Docket Item # 7 & 8 BAR CASE # 2015-00248 & 00249

BAR Meeting September 2, 2015

ISSUE:	Permit to Demolish and Certificate of Appropriateness for Reconstruction and an Addition to the former Beachcombers
APPLICANT:	Old Dominion Boat Club
LOCATION:	200 The Strand (Formerly 0 Prince Street)
ZONE:	WPR/Waterfront Park Recreation Zone (Rezoned in April 2015)

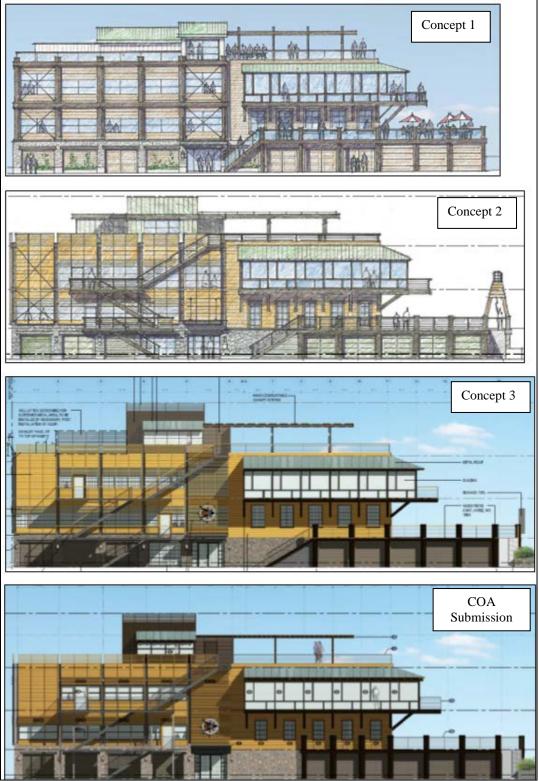
In the concept review submissions, the applicant proposed to activate the first floor at the corner of Prince Street and The Strand by installing the ODBC retail shop for the purchase of ODBC logo items and install interpretive display windows. The retail shop has been deleted in the current submission and the previous interpretive display windows have been converted to panels. Staff is concerned that the first floor along The Strand will be very unwelcoming if the pedestrian is exposed to a 34.5' wall with two-dimensional interpretive panels. The display windows would provide depth and interest, and visually activate this façade. It is recommended that the applicant continue to explore alternatives for this location.

In addition to the panels, the applicant is proposing to interpret the 1845 pier line with an alternate material within the parking lot. Since the City process to select a waterfront common elements palate of materials to delineate the different periods for the shoreline and pier line is

Finally, as part of the DSUP, the applicant is required to design and develop a coordinated sign plan for all proposed signage, including a color palate, site-related signs, way-finding graphics, and interpretive signage for the site. The applicant has provided illustrations of the proposed signage for the building, but an overall coordinated sign plan has not been provided.

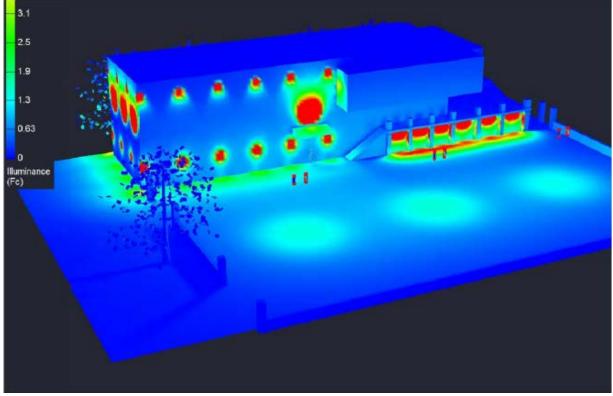
In the previous concept work sessions several board members expressed concern with the design of the mechanical penthouse and its overall visual bulk (see illustrations in Figure 1 below.)

elevators. At that hearing, concerns were expressed about the size and bulk of this mechanical penthouse as well as the potential visibility of the kitchen vents proposed to be installed on the western roof of the building. In the Concept 3 submission, the attempt was to integrate the penthouse into the building by incorporating a wood lattice screening for the rooftop mechanical equipment and extend the length screening around the western roof. In this current submission, this screening has been deleted, and the HVAC penthouse above the elevator has slightly been reduced in length, however the overall width of mechanical structure has increased by approximately one-foot in length. While staff believes the applicant is working toward improving this feature, the penthouse still continues to be a concern, and mechanical drawings must still be provided demonstrating that the minimum space necessary for necessary mechanical equipment is being provided. Staff asks for further clarification and study to reduce its height and bulk wherever possible. This study should include the possible elimination of the HVAC penthouse above the elevator.

- Work with BAR staff on materials and finish specifications
- Restudy the size of the mechanical penthouse
- Restudy height of waterfront stone wall facing the promenade.
- Restudy the design for the Interpretative panels
- Restudy the lighting design/illumination levels at the southeastern corner of the building
- Provide details for the balustrade and front step handrail
- Provide a coordinated sign program for the site
- Ensure that the project complies with the Common Elements adopted as part of the Waterfront Plan.

EXTERIOR ELEVATIONS

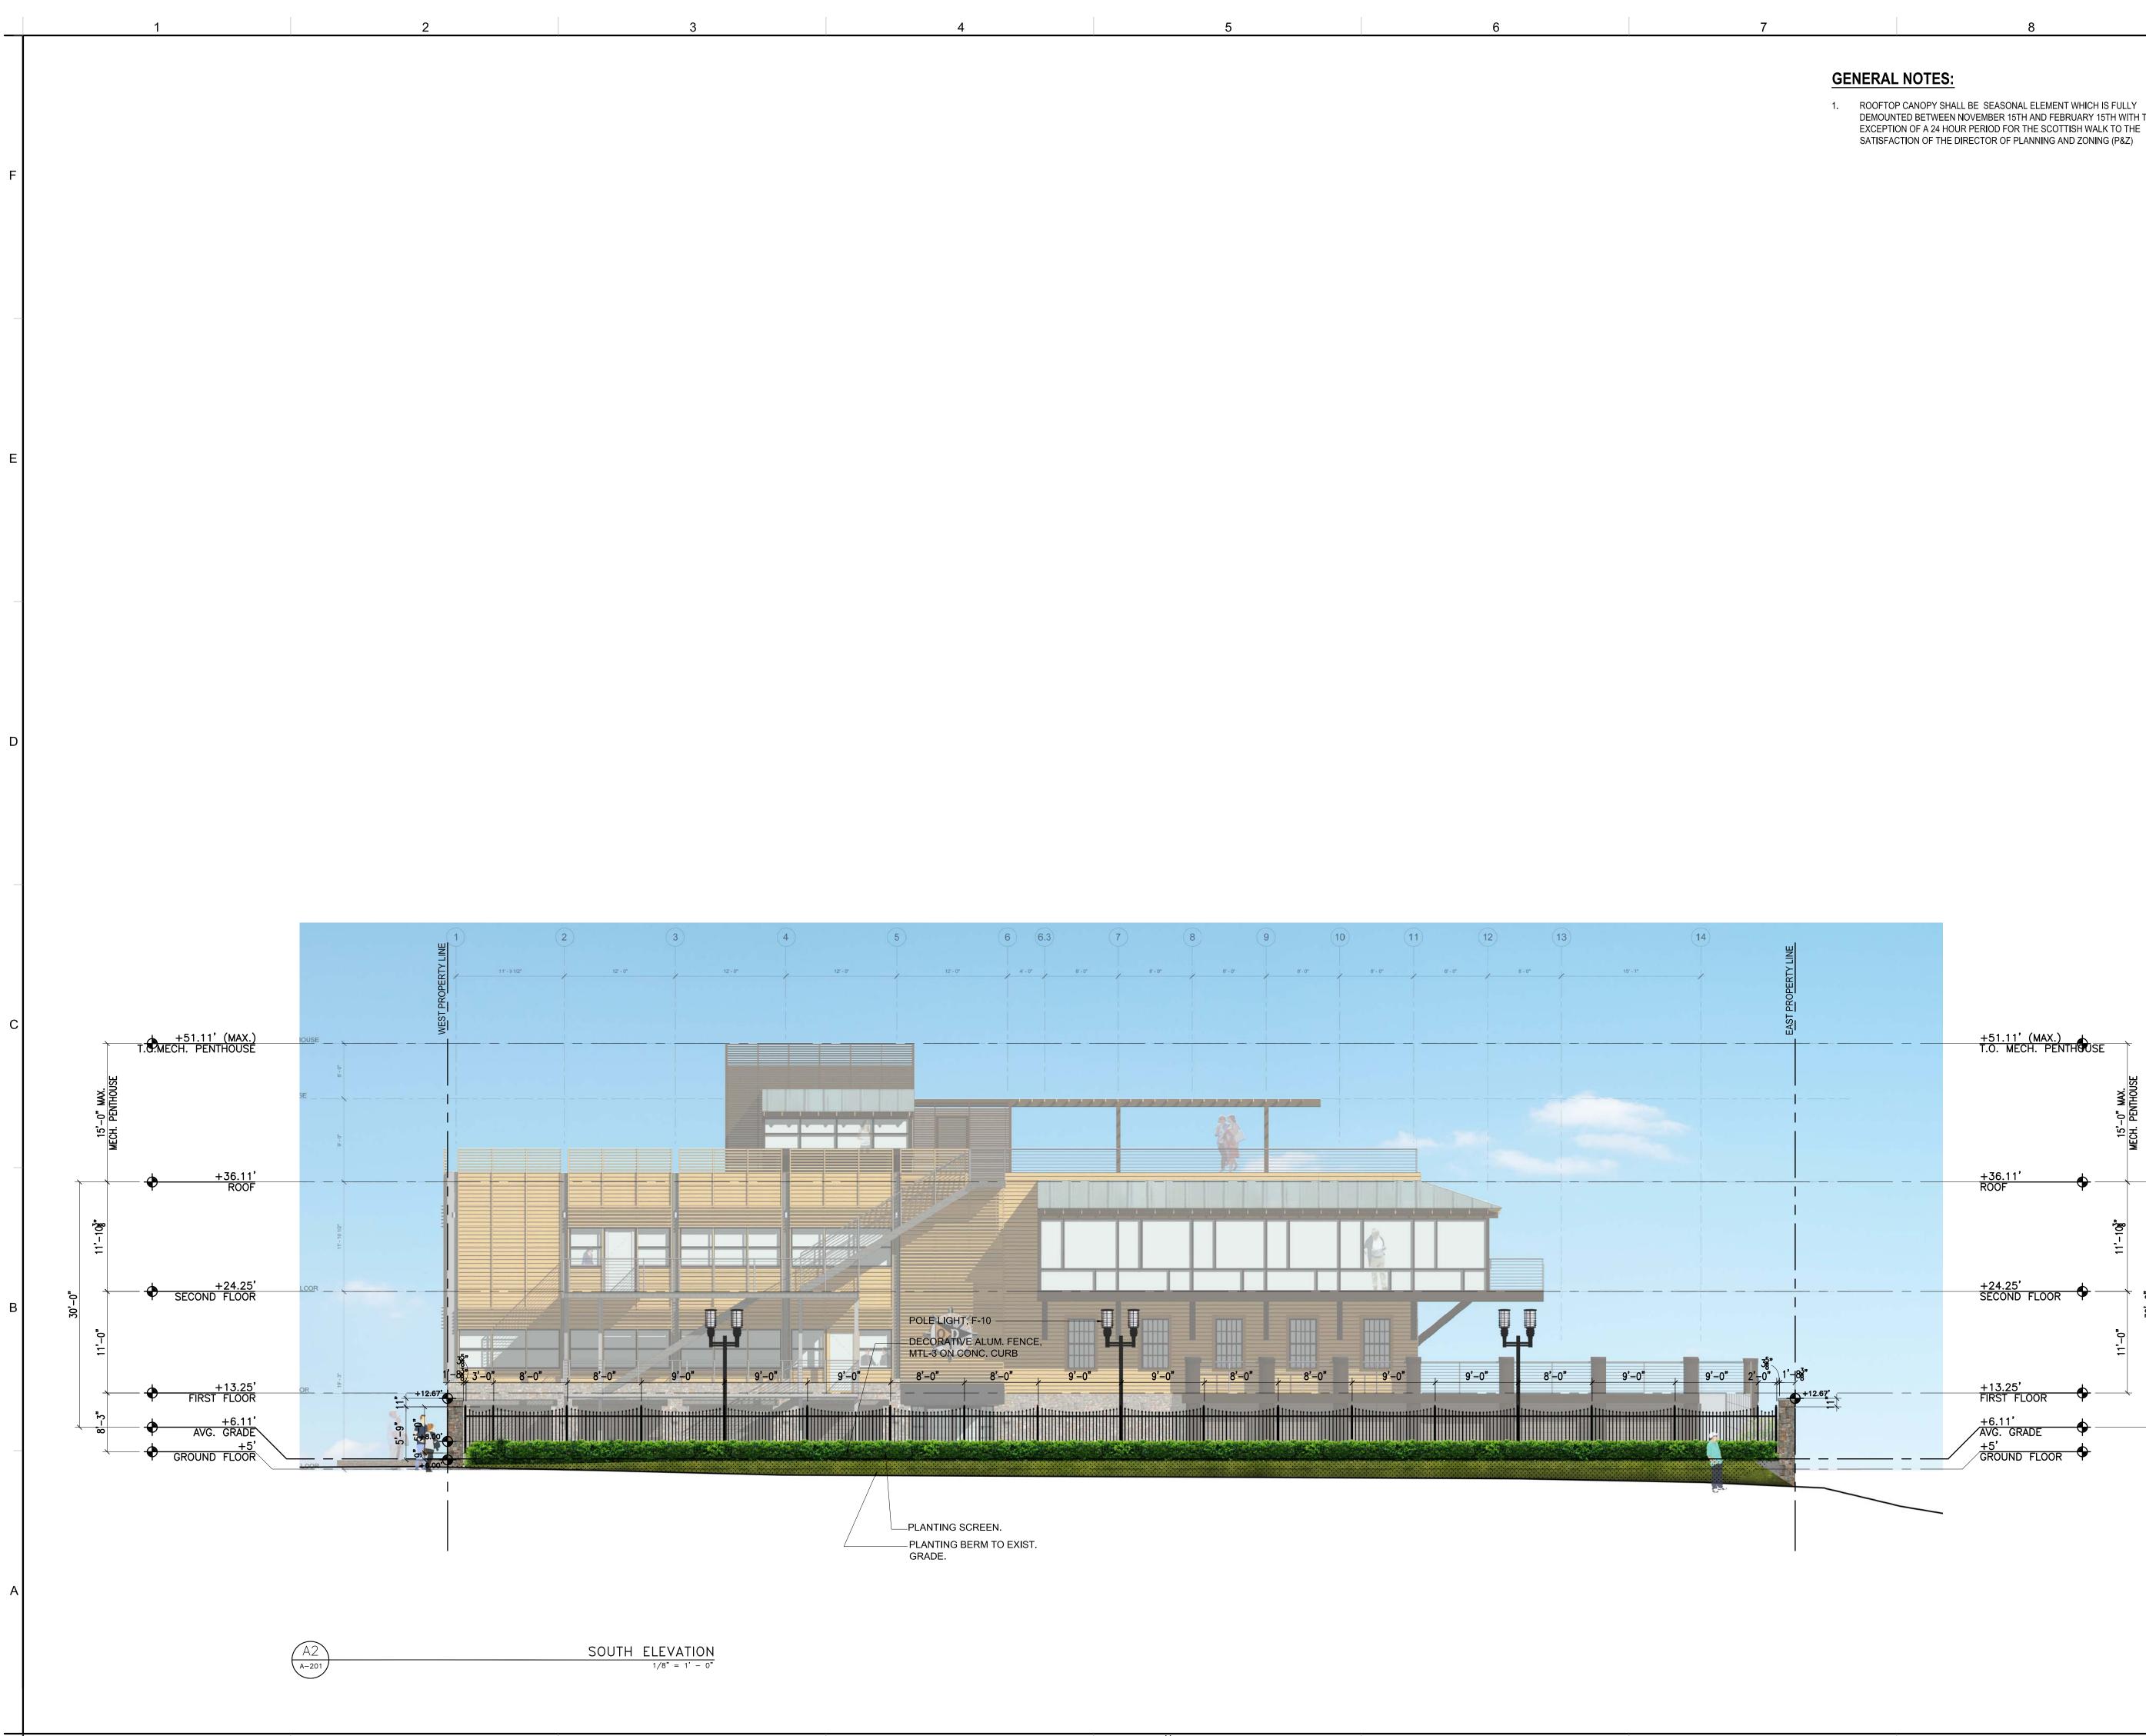
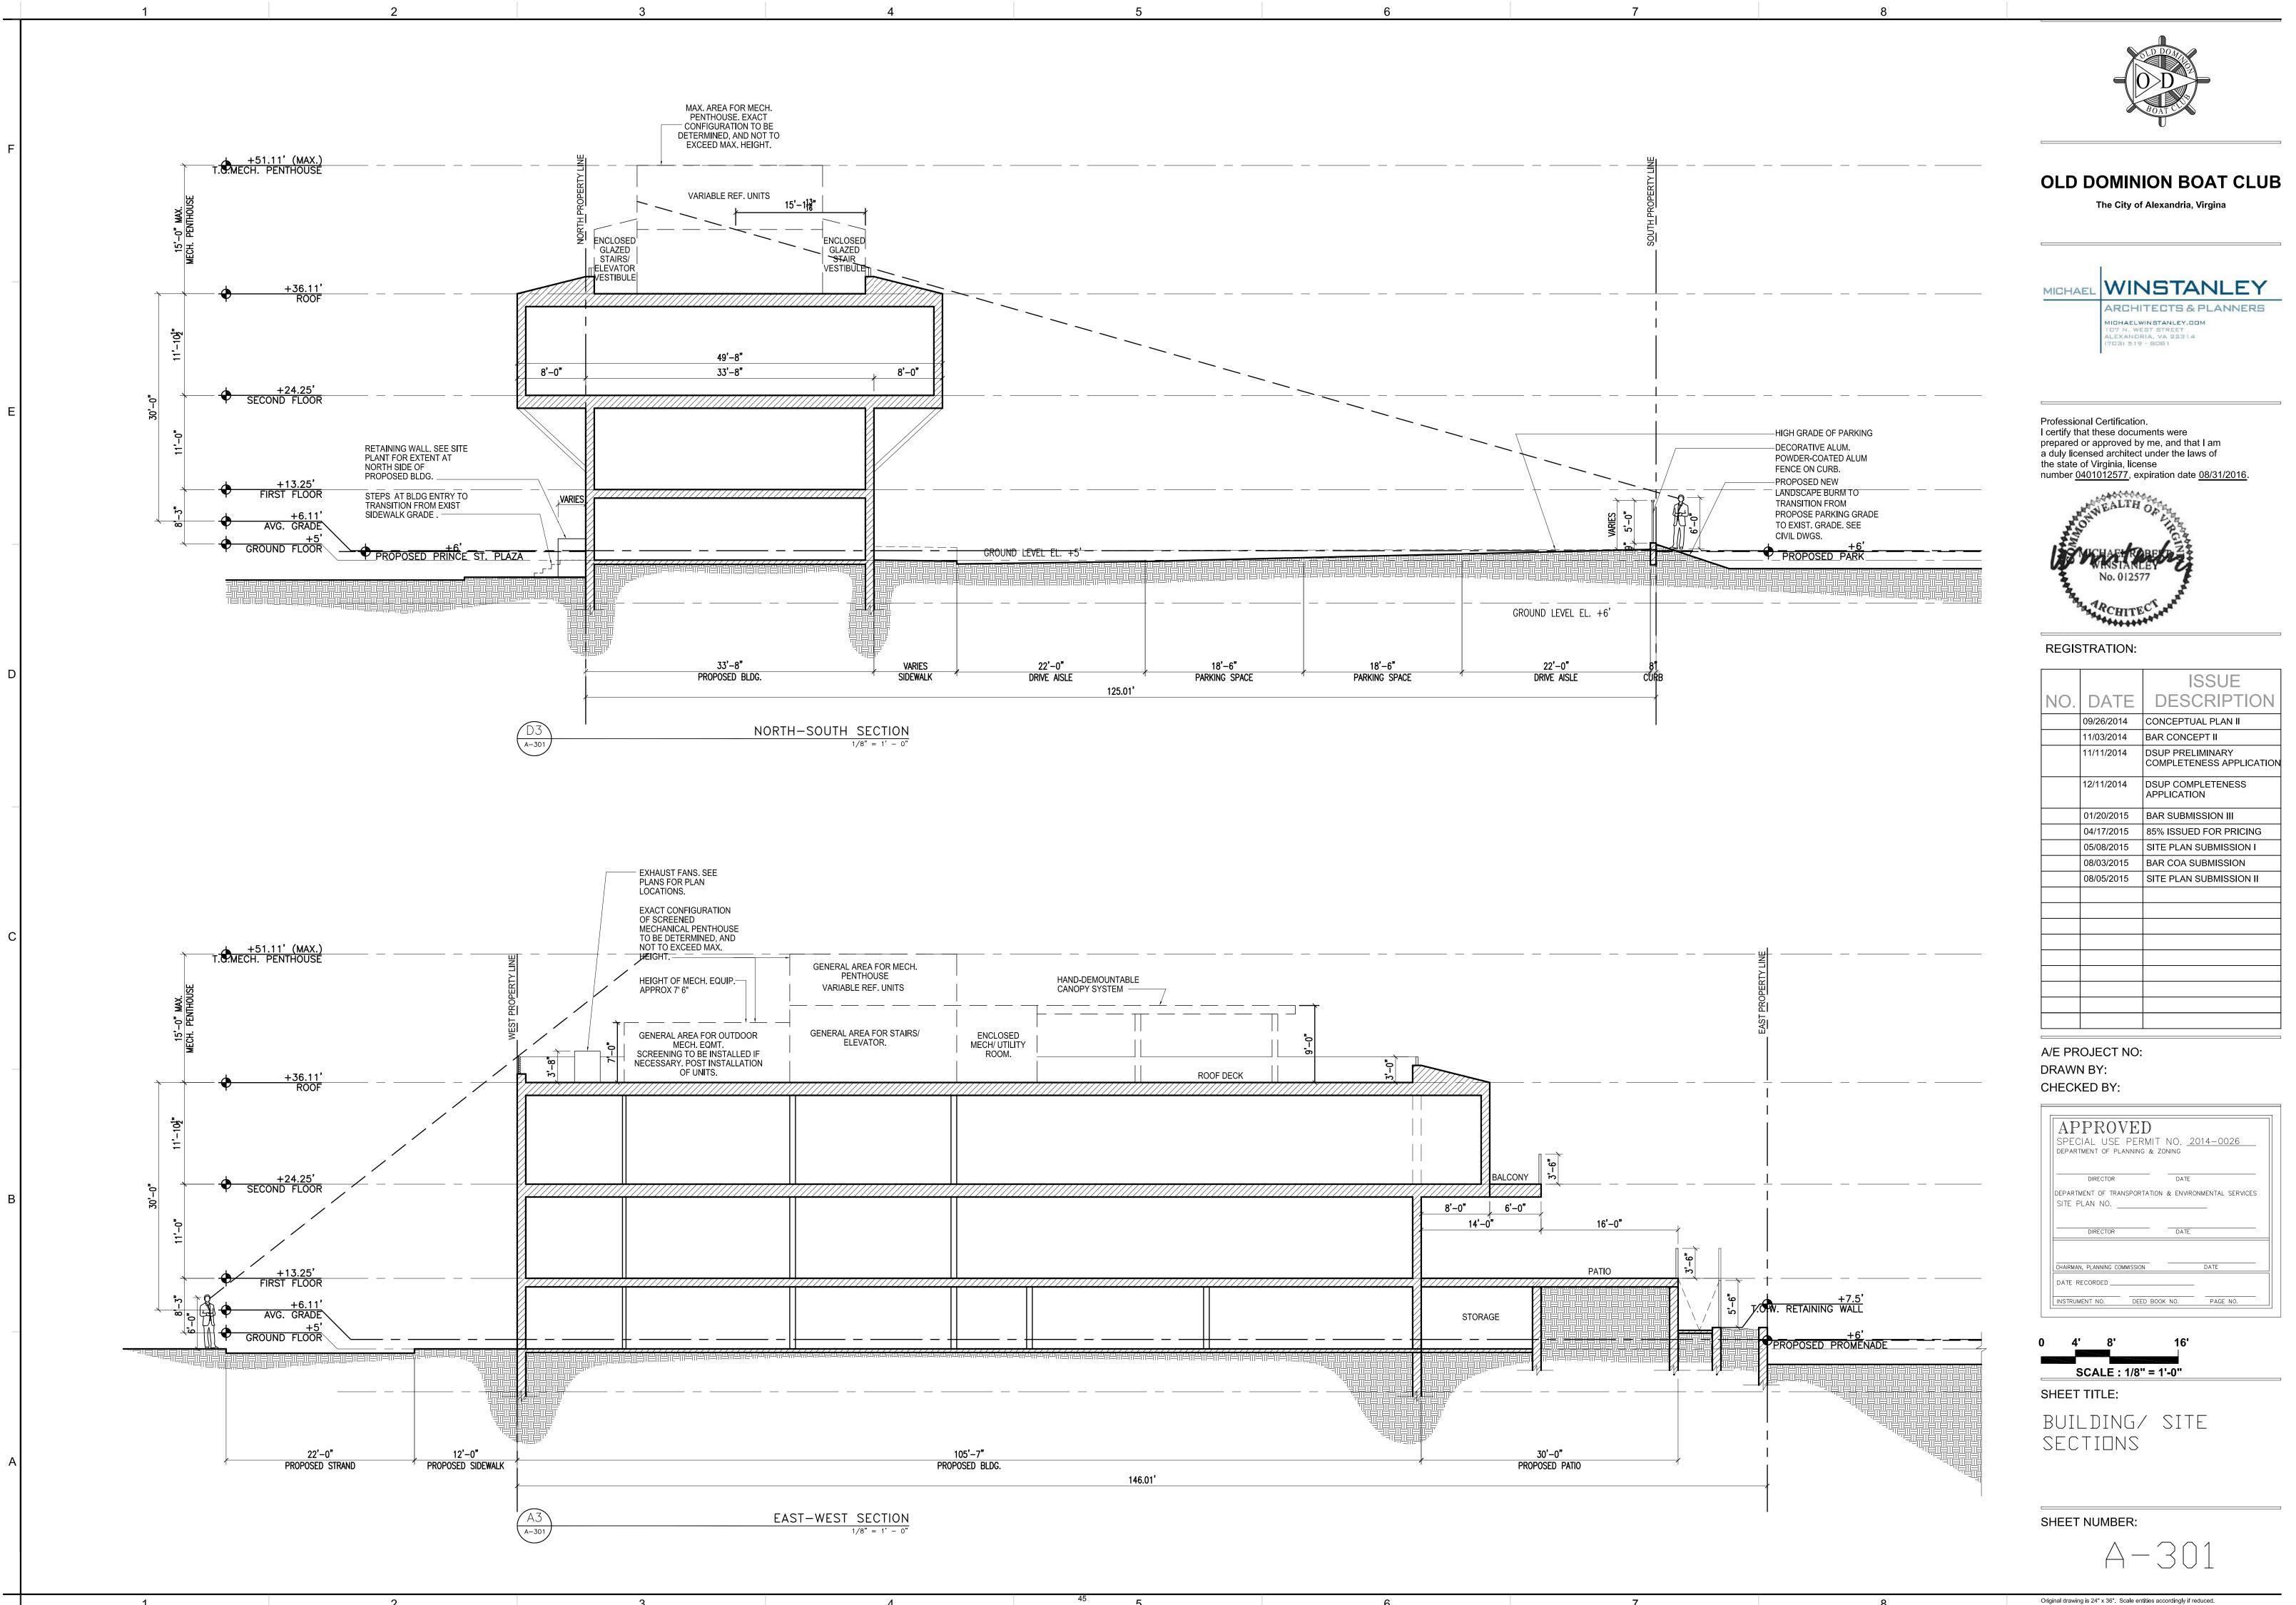
- A-113: the roof over the second floor balconies appears to have increased in area, please amend to the size approved.
- A-201 and all associated sheets: the elevations and 3D rendering do not appear to be coordinated with the floor plans. For example:

- i. the location of the exterior stair from the patio to grade on the south elevation is shown differently in plan and elevation/ 3D rendering.
- j. A-202 and A-202A indicate the southernmost pier against the building face rather than allowing the patio to return around the corner as shown in the plans. This issue potentially impacts the storage areas under the building, the GFA and the ramp/landing from the patio to the promenade.

Based on sheets A-202 and A-203 the proposed fence is at most 6'8" to 6'3" in height in these yards. The BAR must approve the modified height in the required yard, however; the site plan should be amended to reflect this approved modification in fence height. No modification is needed for the front yards, since City Council granted a zero feet for the required setback.

Please ensure all future submissions include fully updated and coordinated elevations which match the information in the plans.
